Public submission in respect of

**Planning Application 77576 to North Devon District Council  
WHITE CROSS WIND FARM**

*NGED Network Capacity mapping*

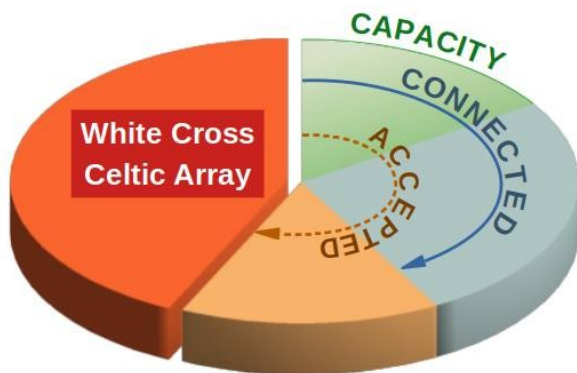
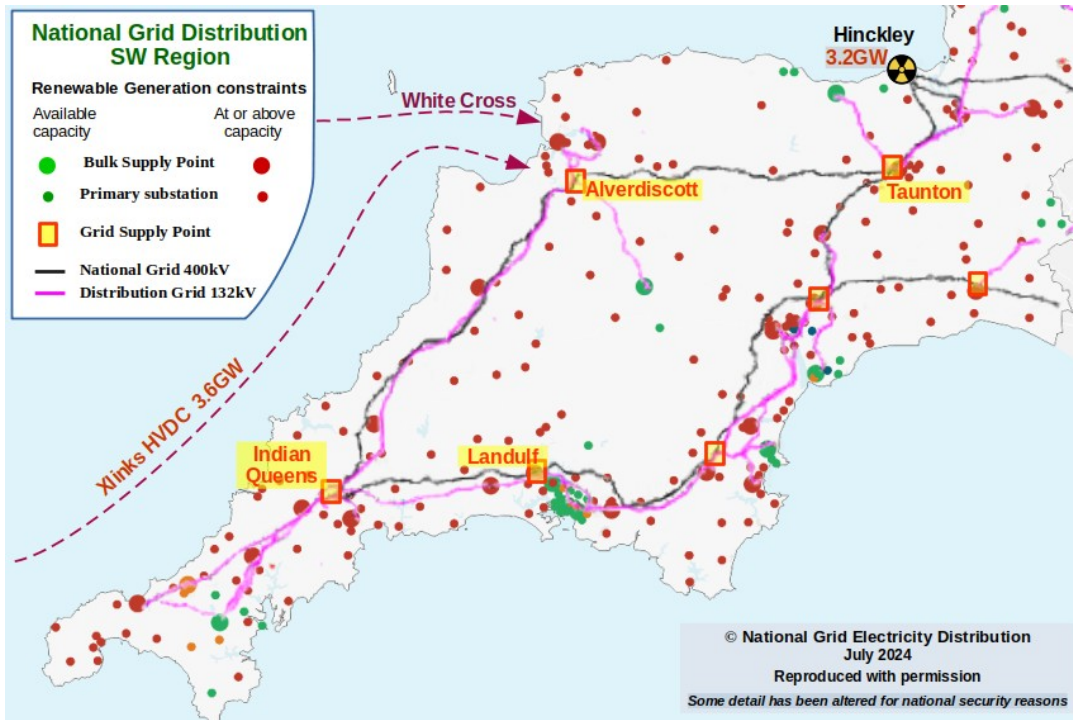
East Yelland has a 60 MW transformer which already offers connections for renewable generation at more than 160% of its reverse-power capability.

The additional 100MW from White Cross is far beyond the operational limits of the East Yelland transformer and the overhead cable connections to Alverdiscott.

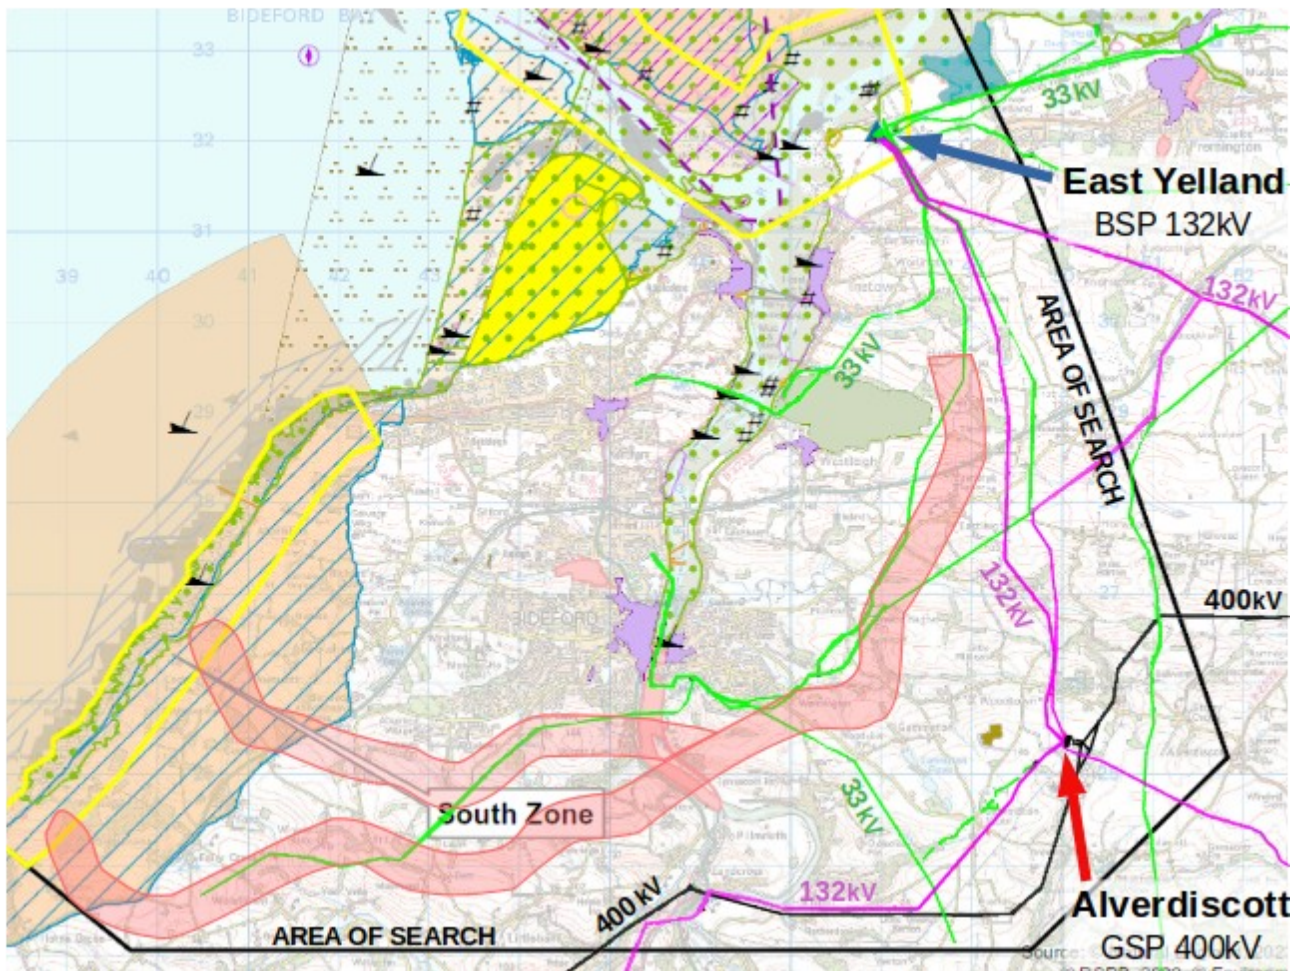
The document starts by identifying East Yelland substation as the “*Potential Grid Connection Location*”. No other alternatives are referred to, despite Alverdiscott Grid Supply Point (GSP) being within the area of search.

Either of two main southern routes would be preferable if they had continued east to Alverdiscott instead turning north.

By ignoring Alverdiscott as the eventual destination for the electricity from the Celtic Array, the Applicant is creating a false argument... attempting to show that the onshore cable route would be much longer and more expensive if a southern option were considered.
